Appln. No. 10/657,403
Amendment dated March 30, 2006
Reply to Office Action of January 24, 2006

Amendments to the Drawings:

FIG. 3

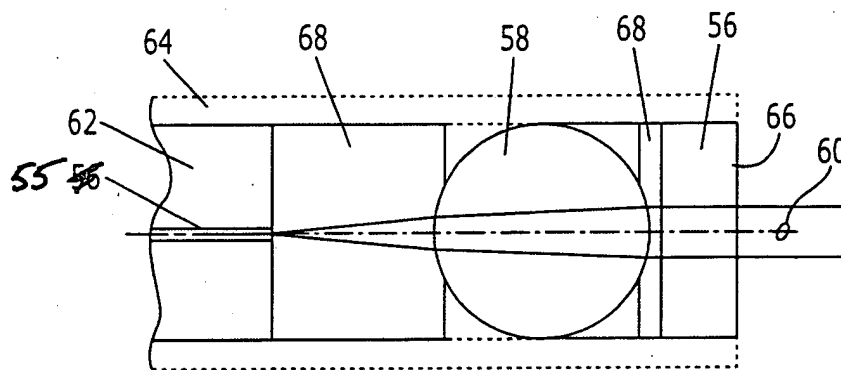
With the consent and approval of the Examiner, Applicants propose to amend Fig. 3 as shown in red in the following sketch:

Applicants propose to amend Fig. 3 of the drawings as indicated in red on the indicated sketch. The change here is to have reference numeral 56 refer to the interface optical element, and to use reference numeral 55 to refer to the optical fiber, as discussed *supra* with respect to the changes to the specification. Clearly, these proposed changes to the drawing do not seek to add "new matter". A new drawing figure to replace Fig. 3 is submitted herewith in the appendix.
